19 August 2019

Pearl High School Multipurpose Building

## ADDENDUM NO. 01

2 WALL SECTION  
3/4" = 1'-0"

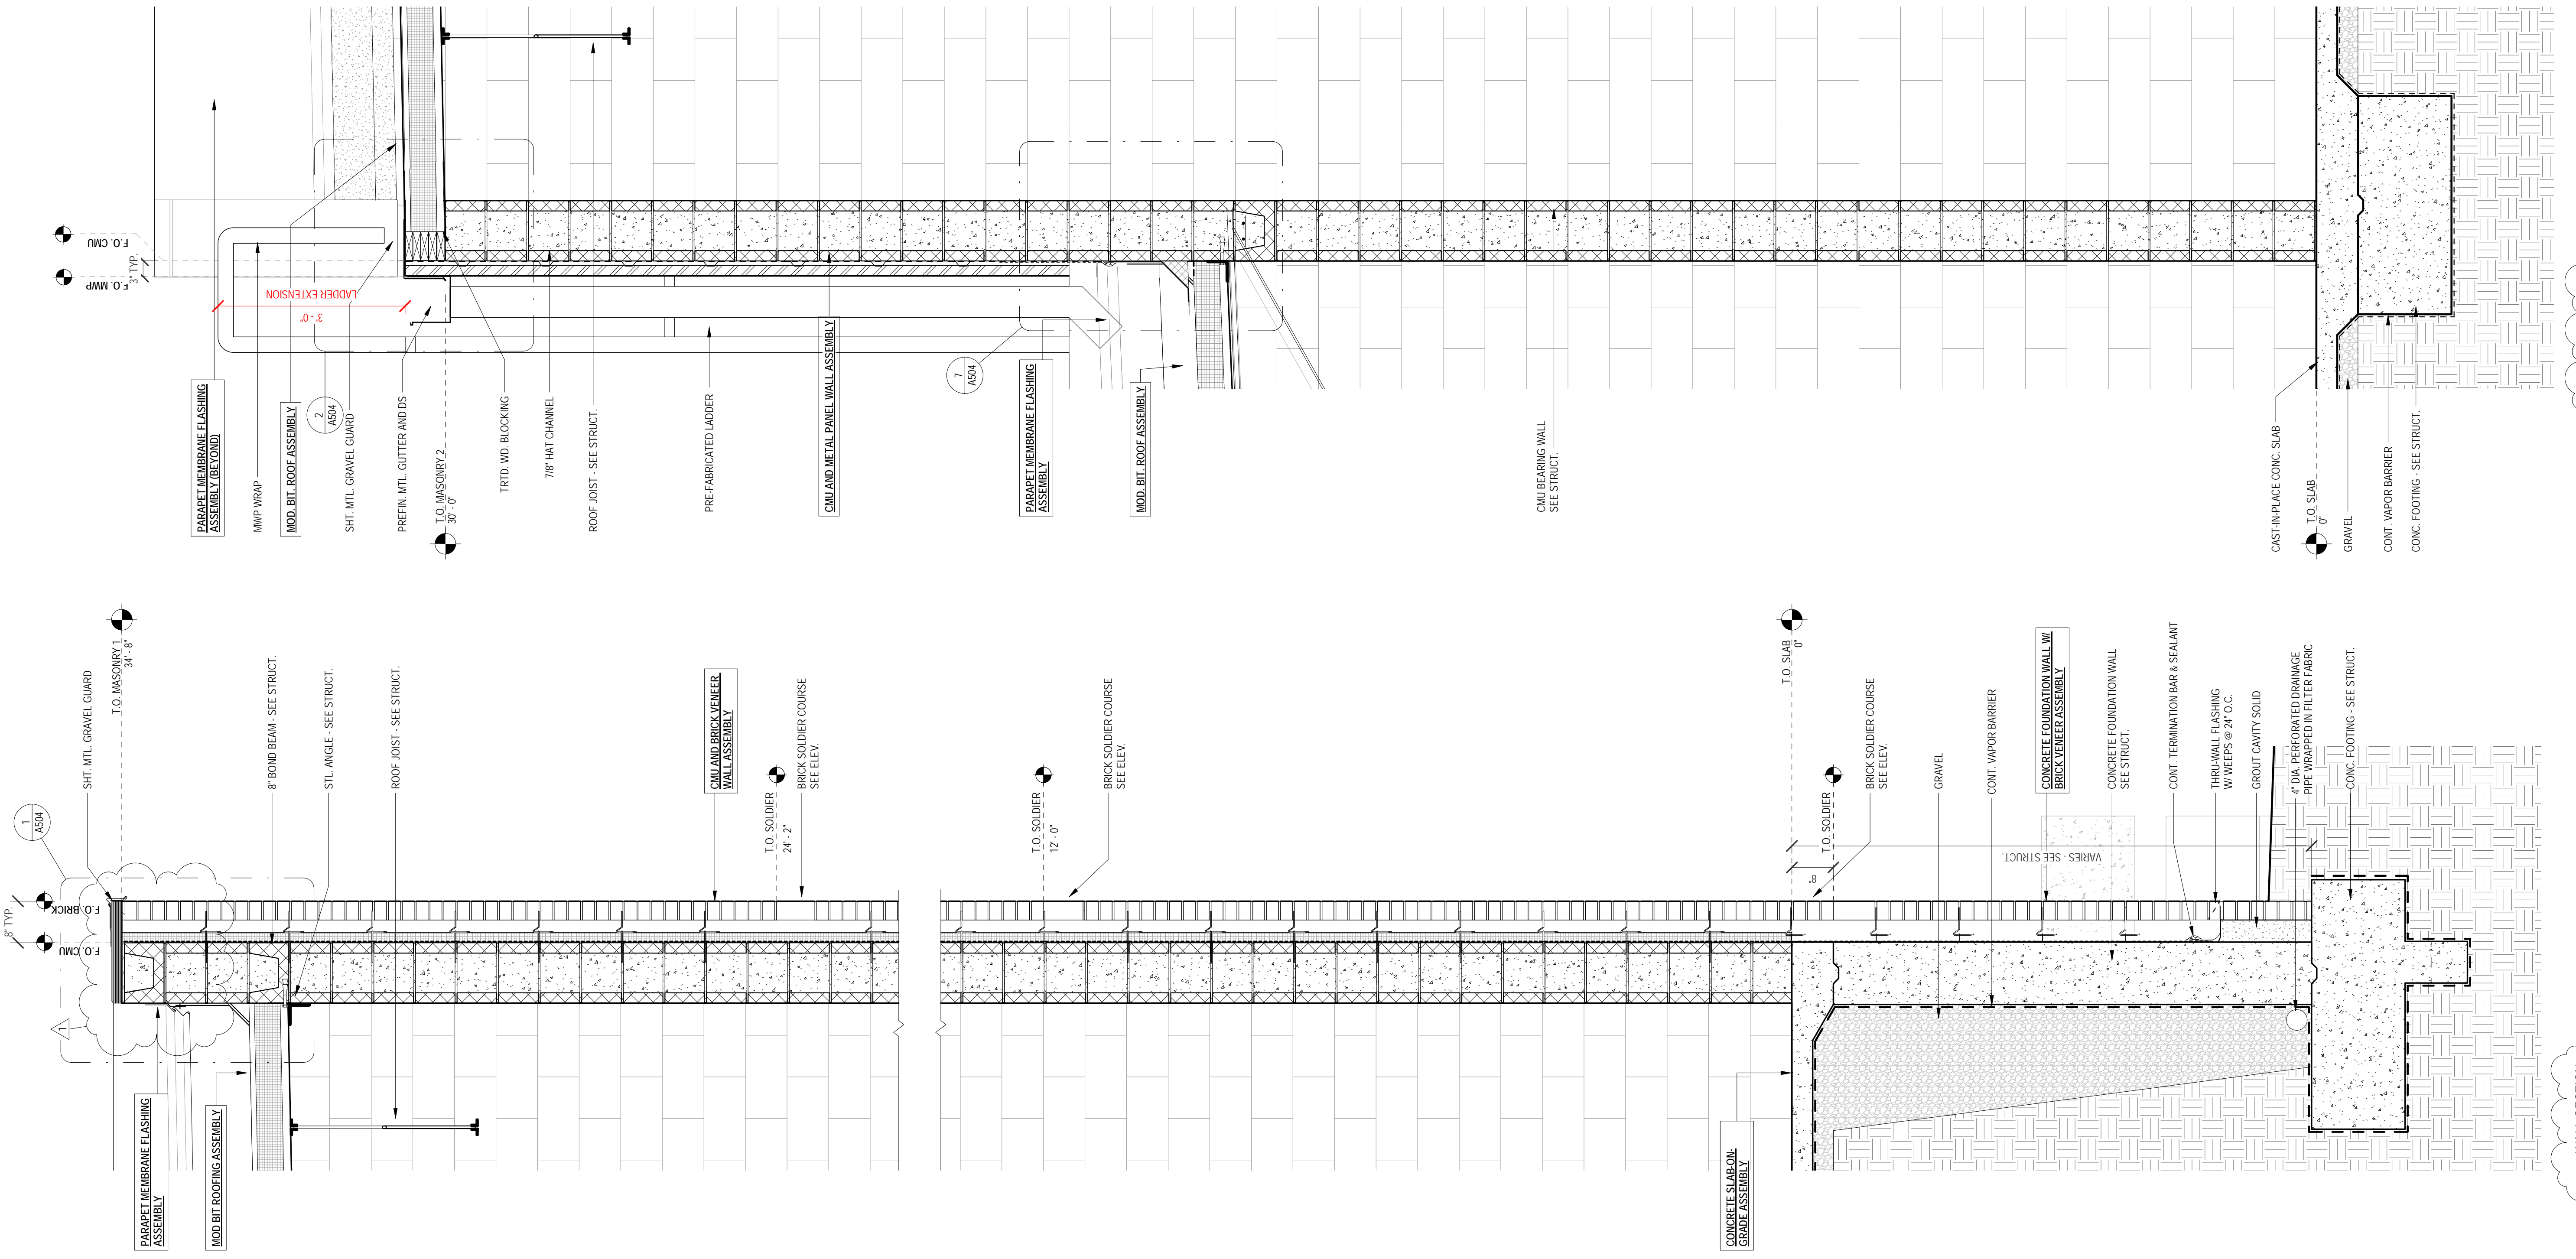
- ITEM NO. 46**      **SHEET A401 WALL SECTIONS**  
*REPLACE* sheet with attached revised sheet A401.  
*Revises* detail 2 to include roof access ladder
- ITEM NO. 47**      **SHEET A402 WALL SECTIONS**  
*REPLACE* sheet with attached revised sheet A402.  
*Revises* detail 2 to include CMU at wall section

**FOUNDATION PLAN**

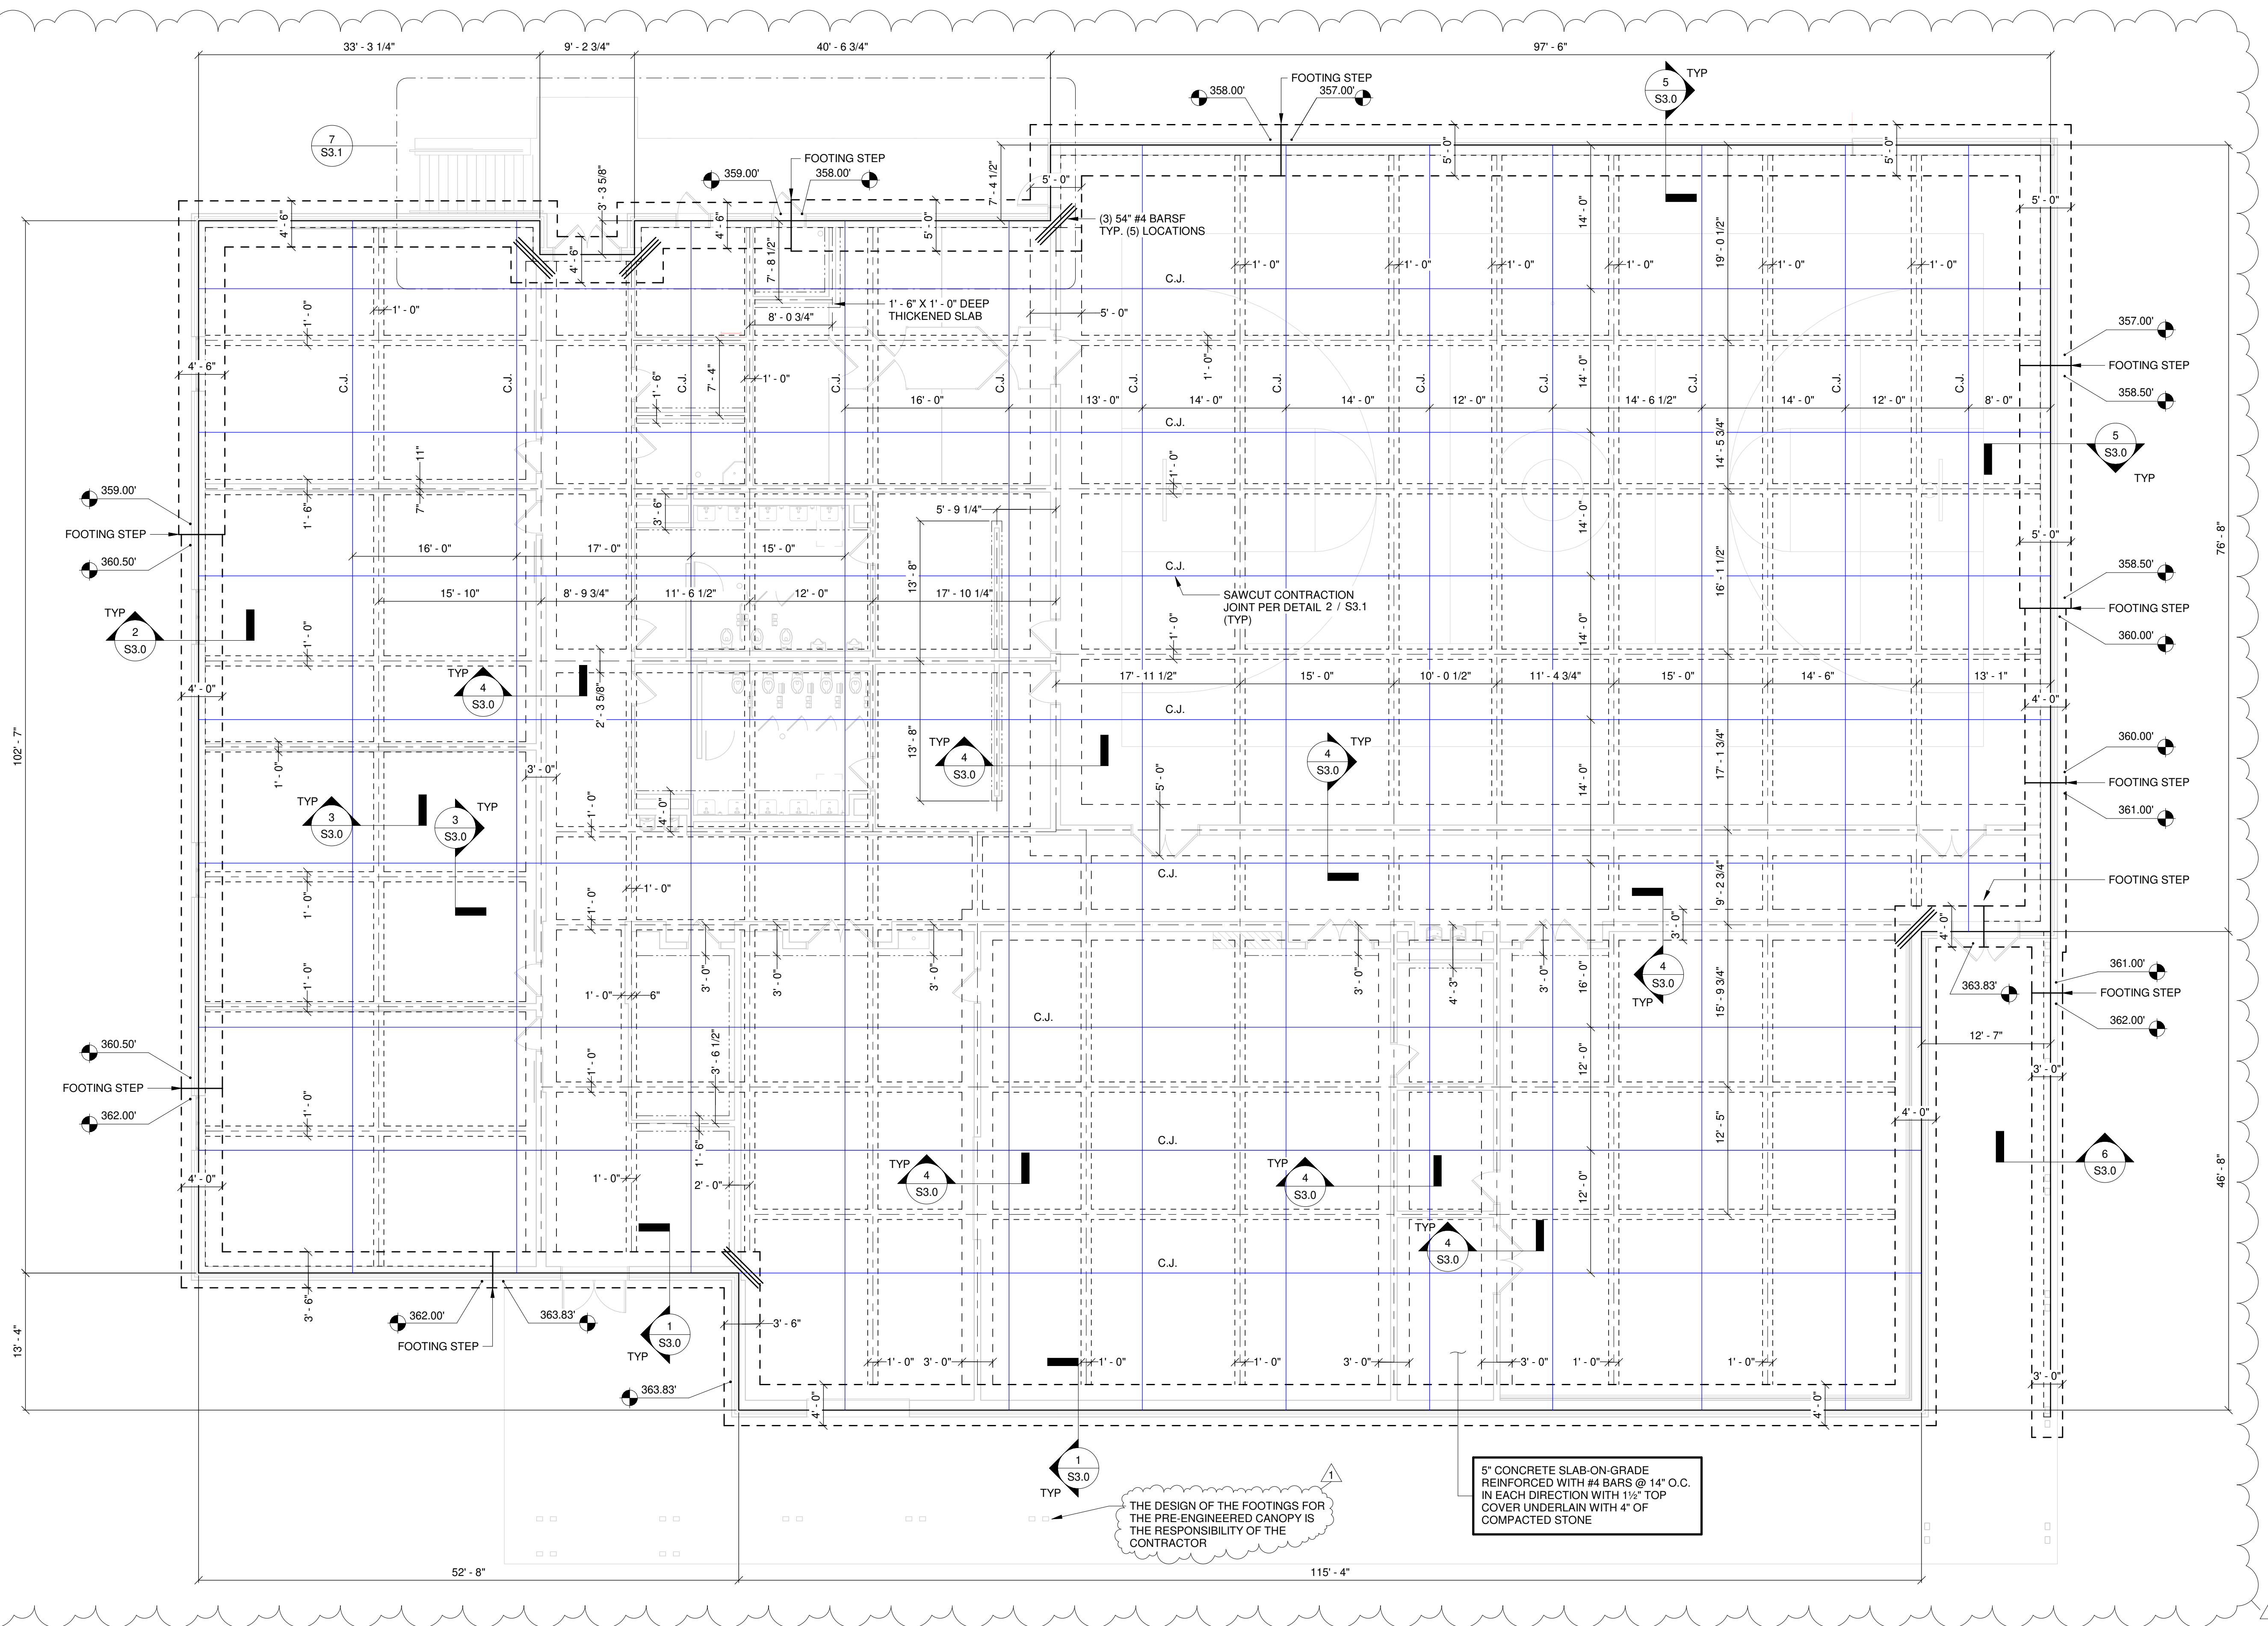
- ITEM NO. 54**      **SHEET S2.0 FOUNDATION PLAN**  
*REPLACE* sheet with attached revised sheet **S2.0**.  
Revises grade beam layout, contraction joint layout, and footing step locations.  
Adds slab reinforcement at inside corners.

# CMU WALL PLAN

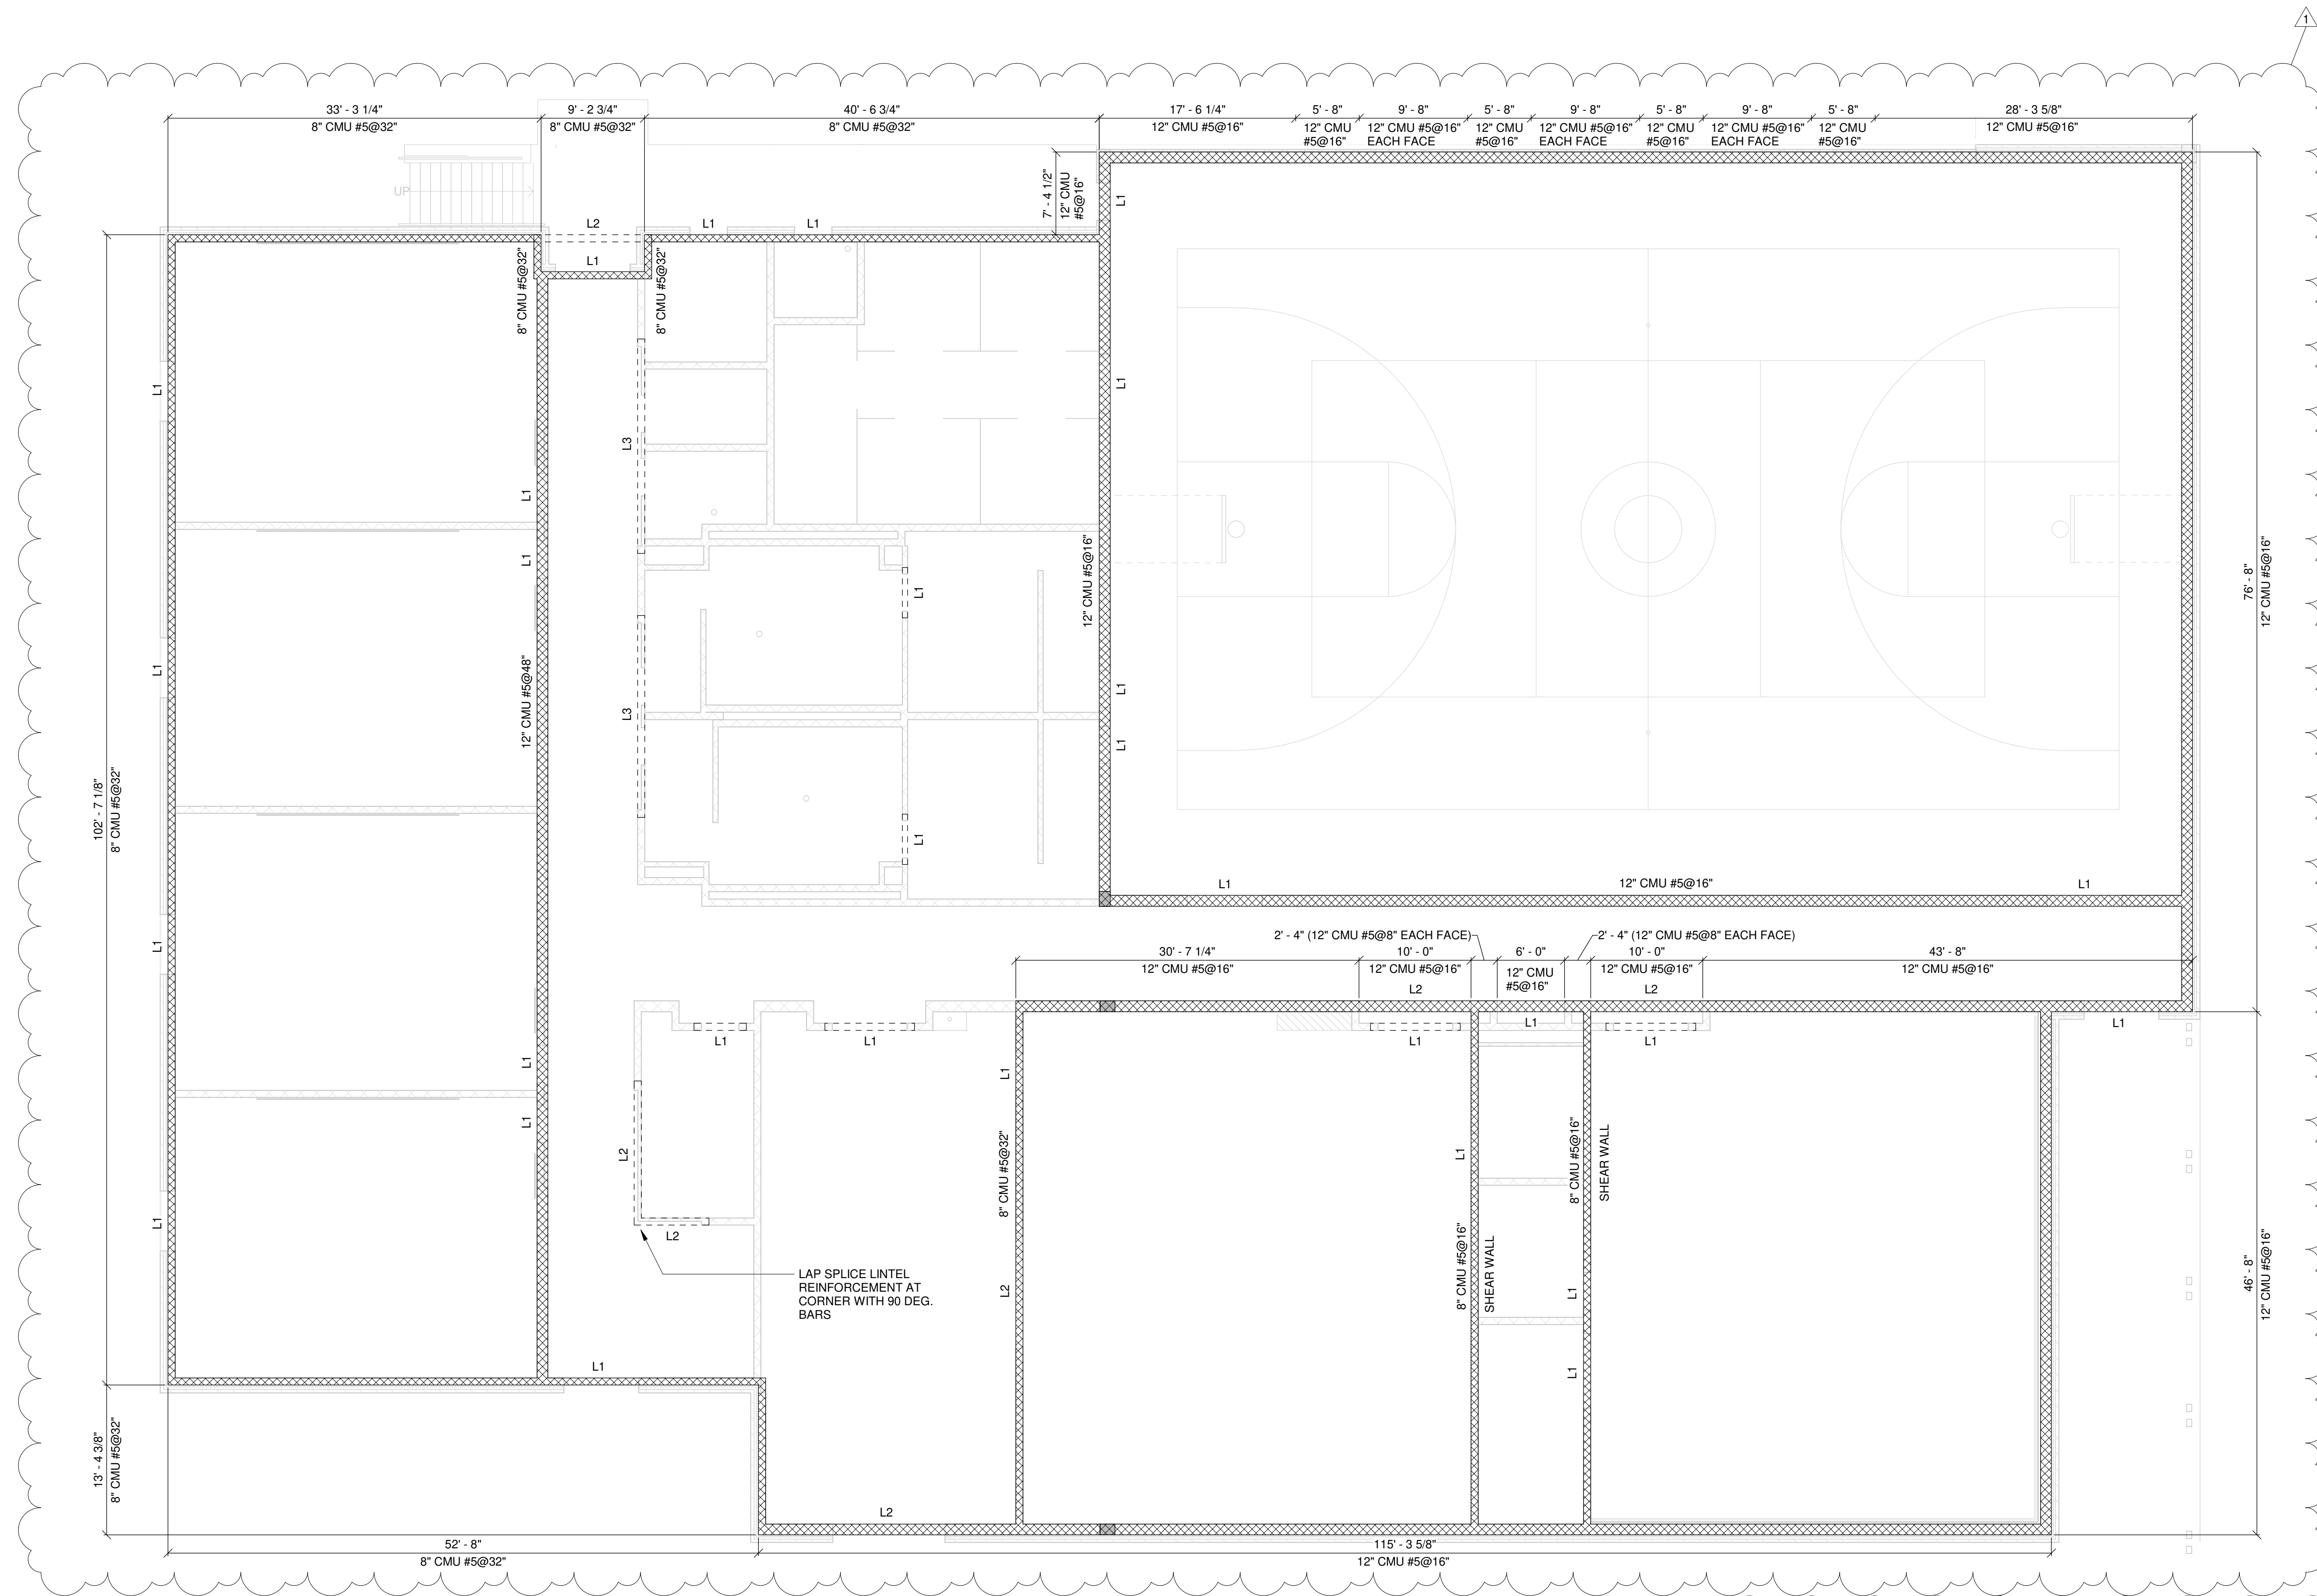
- ITEM NO. 55**      **SHEET S2.1 CMU WALL PLAN**  
*REPLACE* sheet with attached revised sheet **S2.1**.  
Revises CMU wall reinforcement.
- ITEM NO. 56**      **SHEET S2.2 LOWER ROOF FRAMING PLAN**  
*REPLACE* sheet with attached revised sheet **S2.2**.  
Revises roof joist sizes and RTU support framing.
